COMMONWEALTH OF MASSACHUSETTS
DEPARTMENT OF PUBLIC UTILITIES

MASSACHUSETTS ELECTRIC COMPANY AND NANTUCKET ELECTRIC COMPANY EACH D/B/A NATIONAL GRID

D.P.U. 23-150

JOINT DIRECT TESTIOMNY OF

Figure 1. National Grid distribution capital spending, 2015–2023 actual, 2024–2029 projected.

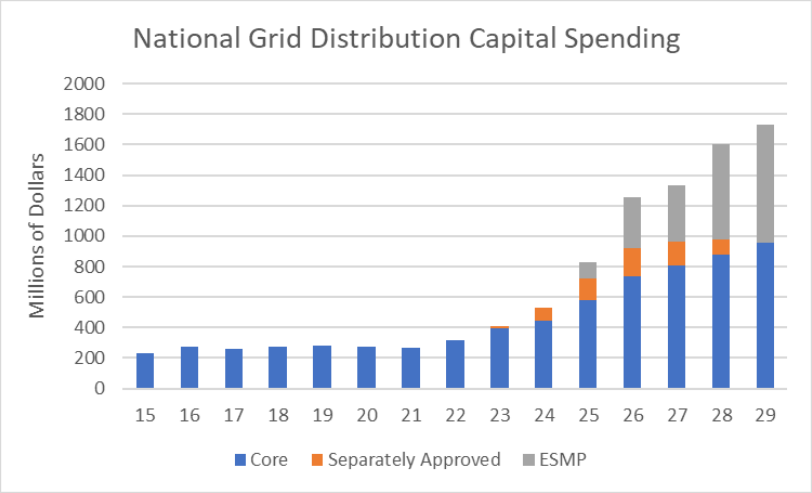
National Grid's CPIP proposes annual capital spending that will sextuple from 2019 ($279 million) to 2029 ($1.73 billion; see Figure 1, below). While increased grid investment may be one objective of ratemaking innovations such as rider cost recovery, there is a vital need for a counterbalance. Without a counterbalance, and given utilities' capital bias,[1] spending is likely to occur too early, be cost-ineffective, or even be counterproductive. ("Capital

In this testimony we will argue that the ratemaking pendulum is swinging too far in favor of unfettered investment, driving associated rate increases that will slow progress toward the Commonwealth's electrification goals. We estimate National Grid's spending plans, in total, will *double* revenue requirements from 2023 ($946 million) to 2029 ($1.862 billion; see Exh. AG-WG-4 for summary calculations). Given low projected sales volume

Figure 6. National Grid SAIDI Performance vs. IPIM Targets

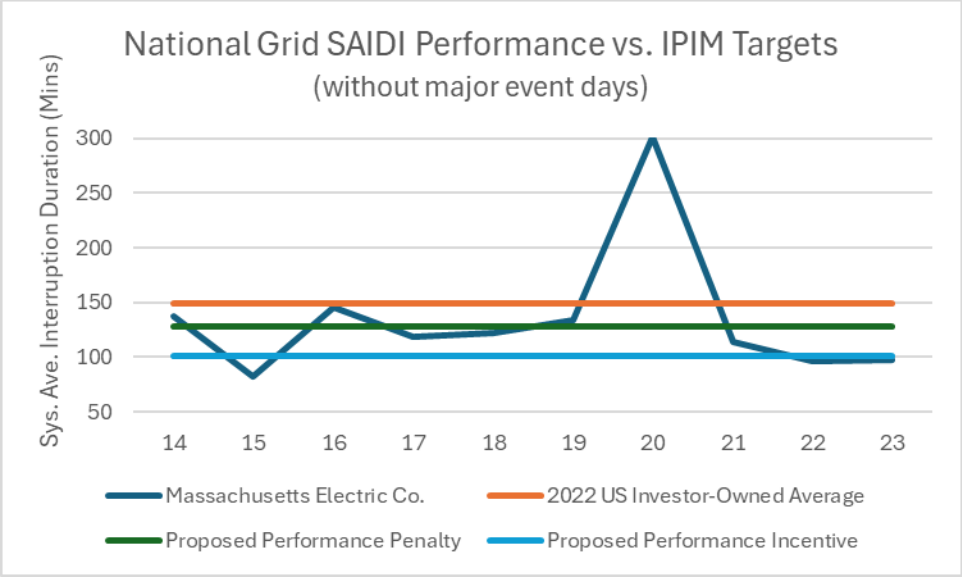
As indicated in Figure 6 below, over the past ten years, these Company-proposed Service Quality PIMs would have resulted in three performance incentive years, four performance penalty years, and three deadband years (no penalty or incentive). Although these targets

appear balanced at first glance, they ignore the massive reliability improvement investments being proposed. This means that while the proposed Service Quality targets may have been appropriate historically, they are insufficiently challenging given the billion-dollar capital cost increase the Company proposes to incur in its CPIP for 2025–2029 to improve upon its historical reliability performance.[29]

Figure 7: National Grid proposed vs. AG recommended Customer and System Requirements budget

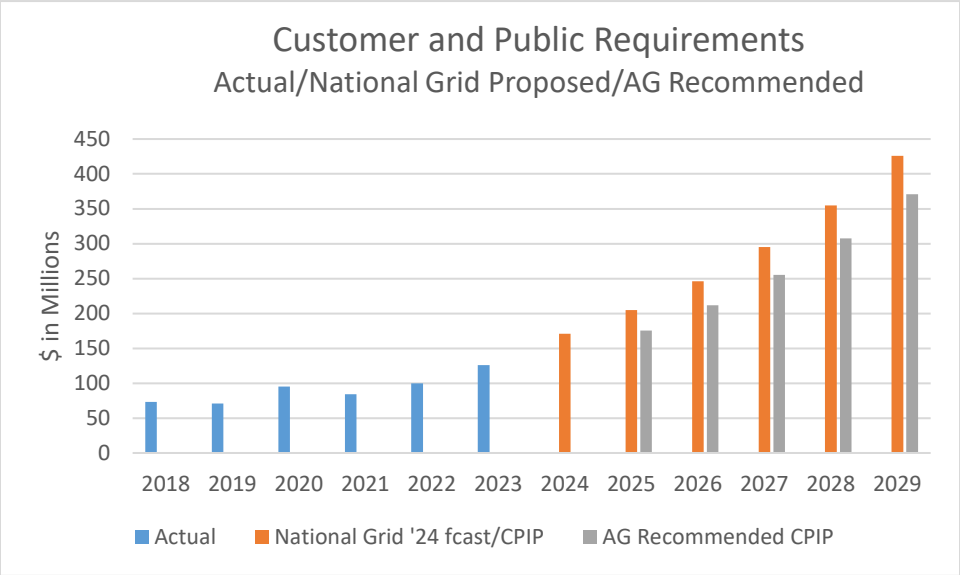
To summarize, the development of a 2025–2029 budget that starts with an artificially high baseline results in an artificially high 2025–2029 budget. By employing the more typical spending in 2022 as a starting point, and growing spending annually by 21 percent, I have calculated a more appropriate 2025–2029 budget of $1.32 billion. I note that the $1.32 billion budget that I calculated is still almost triple the actual spending in the five years ending 2023 ($476 million).[46] I therefore recommend the Department adopt my $1.32 billion budget, reducing the Customer and Public Requirements budget the Company proposed 2025–2029 by $207 million. Figure 7 below compares the capital budget I recommend based on the 2022 baseline to the capital budget National Grid proposes in its CPIP, with historical actual spending provided for reference.

Figure 8. Change in National Grid's Pole Age Distribution over Time

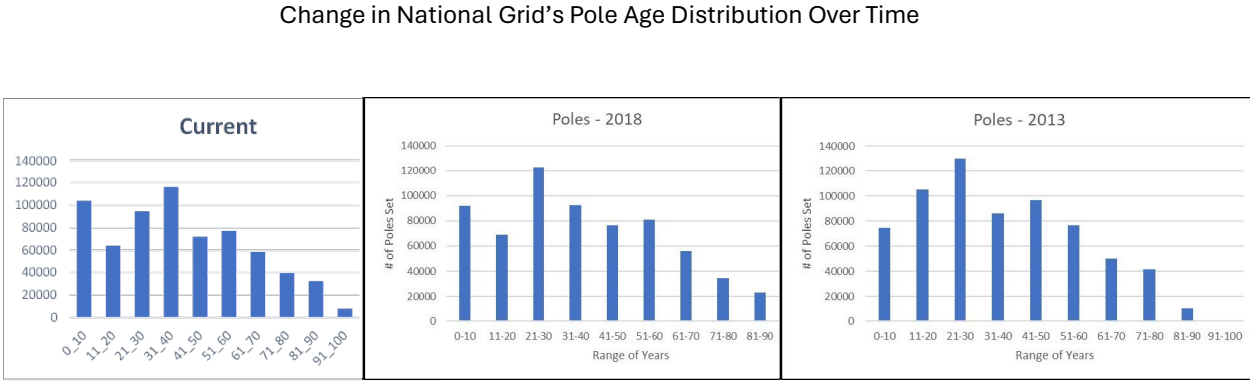
The adequacy of current asset replacement programs and spending levels can be seen in the example of pole ages, presented in Figure 7 below. Note that the distribution of the Company's pole ages in 2013, 2018, and 2022 look remarkably similar.[50] This similarity of pole age distribution over time indicates the Company's current processes and spending levels for identifying and replacing equipment are appropriate. There is no data indicating that the Company should increase pole replacement frequency, as the Company's proposal to dramatically increase its Asset Condition capital spending suggests.

Figure 9. Primary UG Cable Failures Resulting in Service Interruptions, 2018–2022.

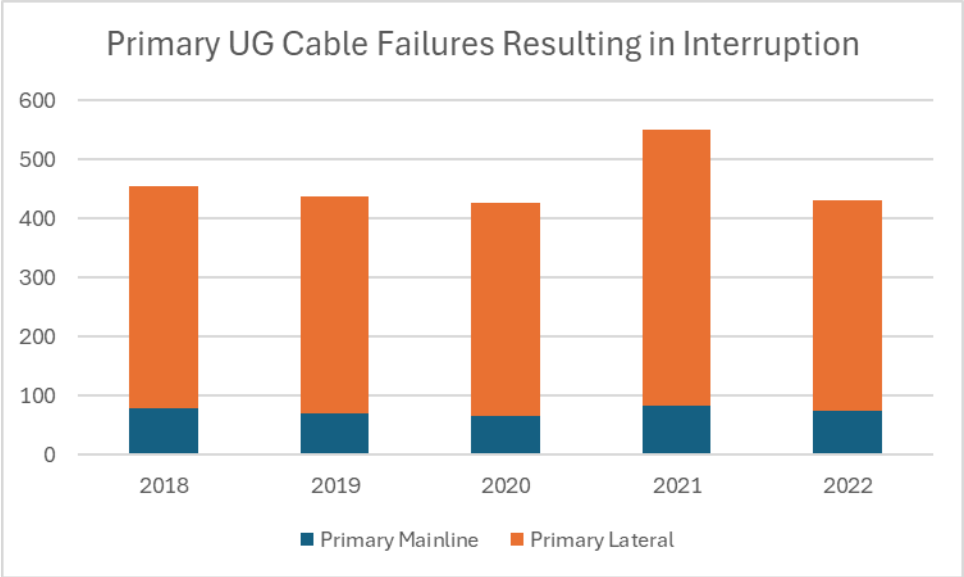
In perhaps the most telling evidence, there appears to be no increase in primary cable failures in recent years, and thus no need for large budget increases whatsoever. Though about one-third of the Company's primary underground cable is direct-buried and more than 30 years old, the primary cable failure rate has remained constant in recent years. Figure 8, below, presents the failure data.[55]
